PD Modification Application: PRS 25-1044**Zoning Hearing Master Date:**

**Hillsborough
County Florida**

Development Services Department

1.0 APPLICATION SUMMARY

2.0 LAND USE MAP SET AND SUMMARY DATA**2.3 Approved Site Plan** (partial provided below for size and orientation purposes. See Section 8.1 for full site plan)

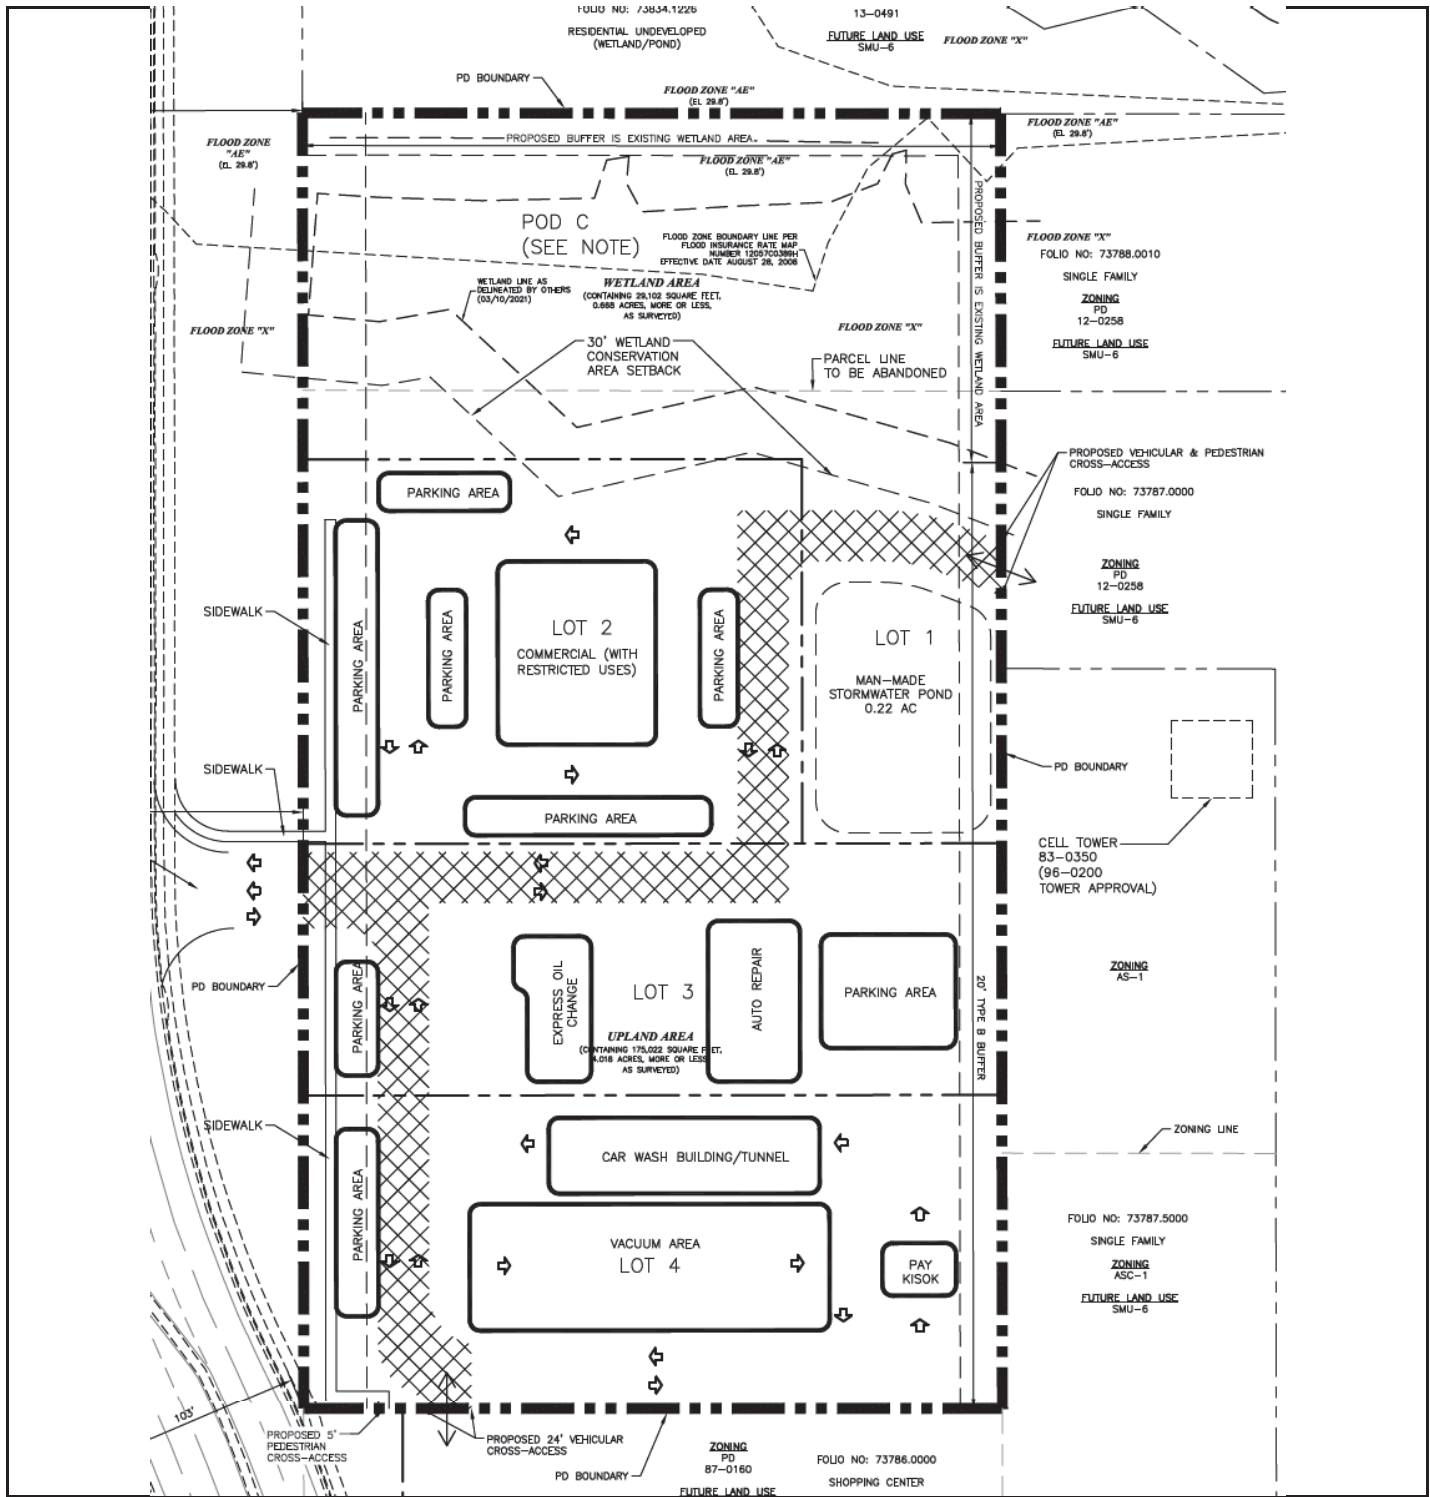
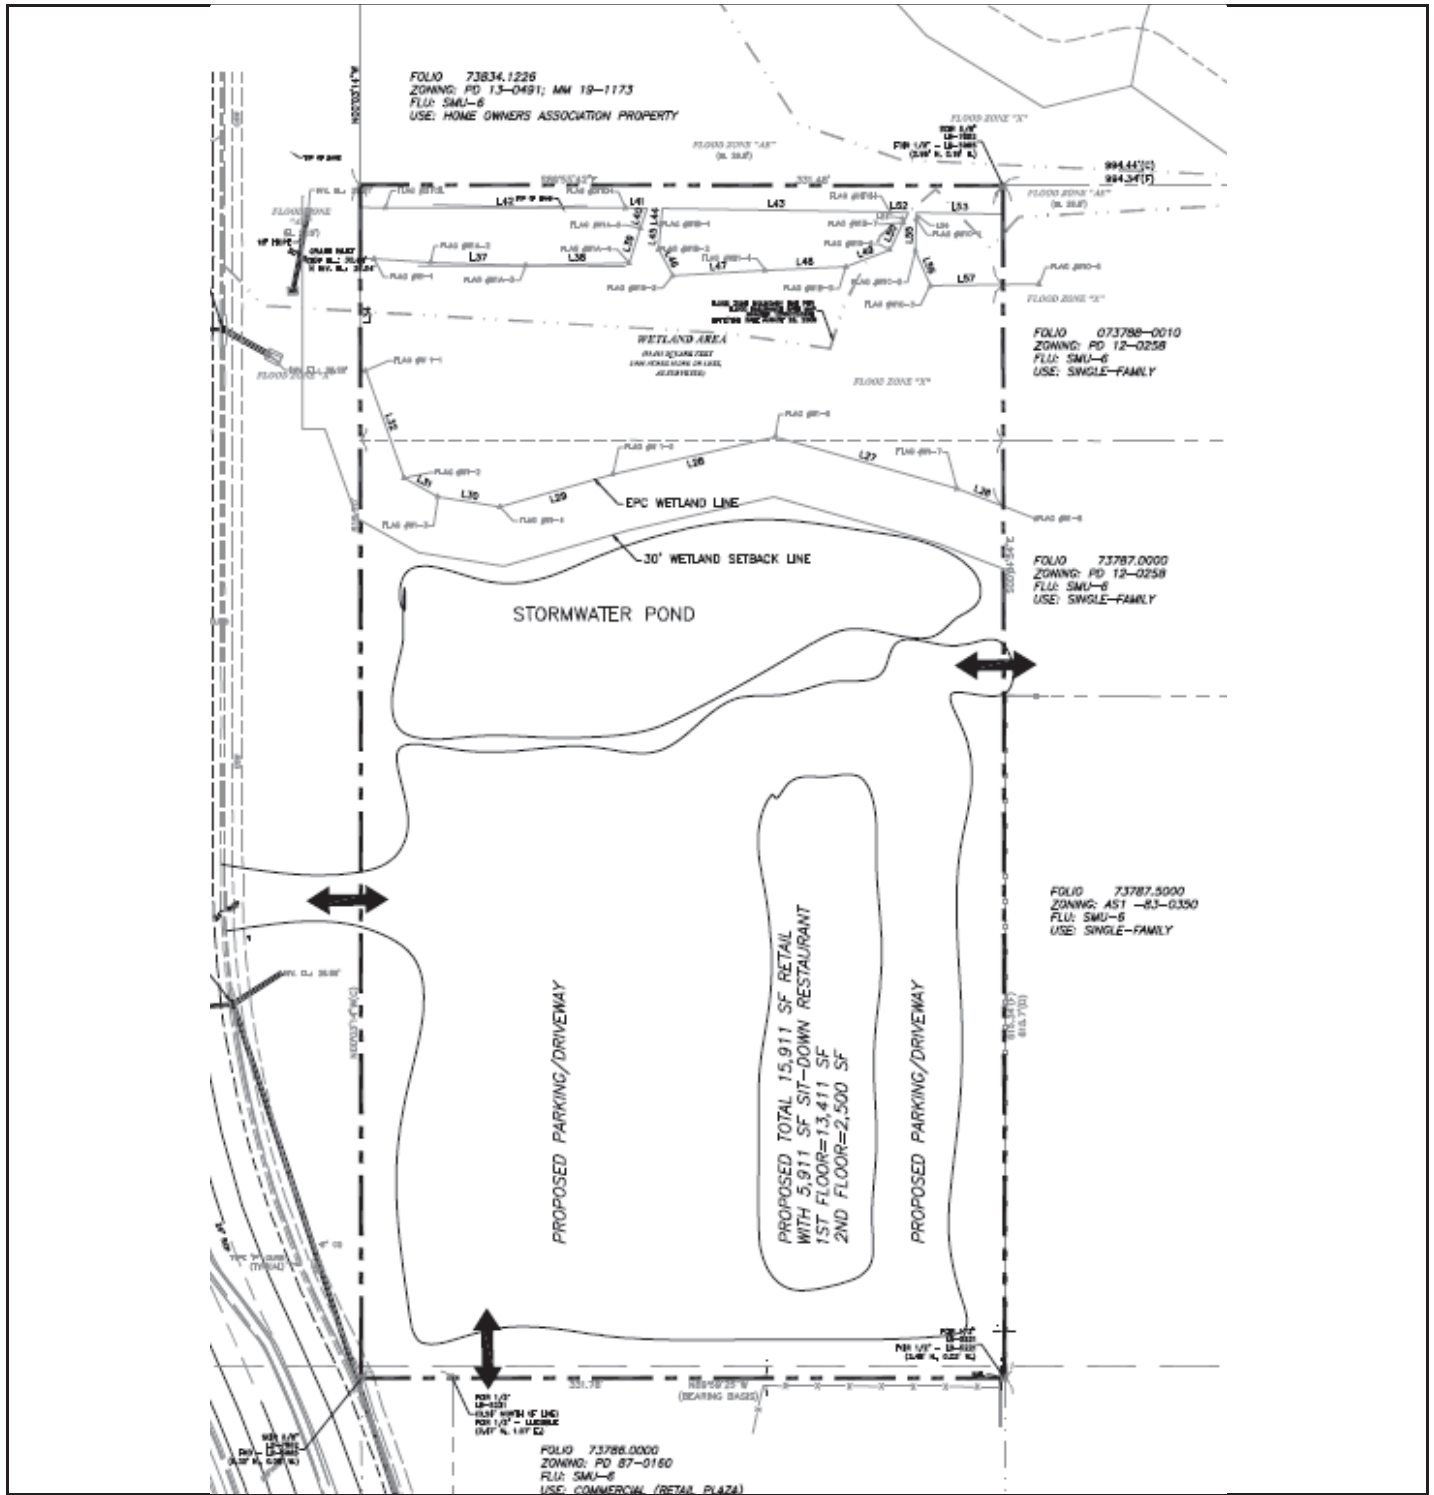
PD 21-0867 was approved in 2021 to allow for a total of 15,911 square feet of retail broken up into 4 lots. The applicant requests modifications to the Planned Development to eliminate some of the uses and reduce the buildable area by condensing the uses into one building and increasing the setback on all property lines.

The proposed modifications to the previously approved Planned Development will not have significant impact on the surrounding area as it is reducing the allowable uses by eliminating the carwash, motor vehicle repair, and medical related retail uses. Furthermore, the proposal has condensed the buildable area into one two story building in the southeastern portion of the parcel which reduced the building coverage. Additionally, the revisions have reduced the building height by 20 feet and increased the setbacks to all property lines. Restricted hours of operation will remain, with specific hours for a sit-down restaurant.

1. The development shall be approved for a maximum of a ~~6,525~~ 15,911 square-foot retail center (restricted to the following commercial uses with no drive-thru facilities allowed: sit down restaurant up to 5000 square feet of indoor area and 911 square feet of outdoor seating; personal services; instructional, such as Golftec; ~~medical office and medical related retail, such as optical stores and appointments, hearing aids, dental and veterinarian, physical and occupational therapy~~; business/professional office; retail food store, such as cupcake sales, cake sales, pressed juices, ice cream, smoothies; cell phone sales and service; soft goods retailers such as jewelry stores, shoe sales, and clothing sales; and food sales designed for off premises consumption, such as deli) in "LOT 2"; ~~a maximum of 5,570 square feet of motor vehicle repair, minor uses in "LOT 3"; and a maximum of a 3,816 square-foot automated car wash facility in "LOT 4".~~

2. Development standards shall be as follows:
 - Minimum lot area: 10,000 Square Feet
 - Minimum lot width: ~~75~~ 100 feet
 - Maximum building height: ~~50~~ 30 feet (2 – Stories)
 - Minimum front (west) yard setback: ~~30~~ 150 feet
 - Minimum side (north) yard setback: ~~In accordance with CC zoning district development standards~~ 300 feet
 - Minimum side (south) yard setback: ~~In accordance with CC zoning district development standards~~ 50 feet
 - Minimum rear (east) yard setback: ~~In accordance with CC zoning district development Standards~~ 50 feet
 - Maximum FAR: ~~0.25~~ 0.08
 - Maximum building coverage: ~~27%~~ 0.08
 - Maximum impervious surface: 70%
3. The landscape buffering and screening shall be in accordance with the requirements of Part 6.06.00 of the Land Development Code.
